ROADSTER
WARRANTY
Bulletin

Campaign no.: 2012-0002

Subject: **Spyder™ RT – RH Lateral Support Replacement**

No. **2012-2**

rbg2012-002-002_a

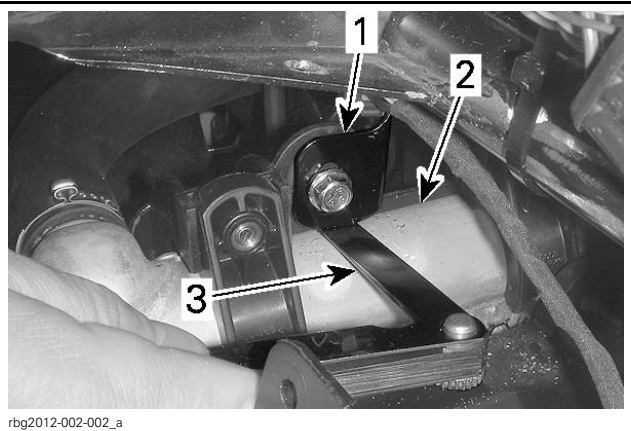
On some units, the RH lateral support may be too close or come in contact with the top of the radiator.

2. Measure clearance.

1. Lateral support bracket
2. Radiator
3. Feeler gauge (stack of 2 mm (.079 in))

MEASUREMENT RESULT	ACTION
2 mm (.079 in) or more	No action required. Reinstall removed parts.
Less than 2 mm (.079 in)	Replace RH lateral support by (the (P/N 548 873 130)) Refer to the appropriate shop Manual)
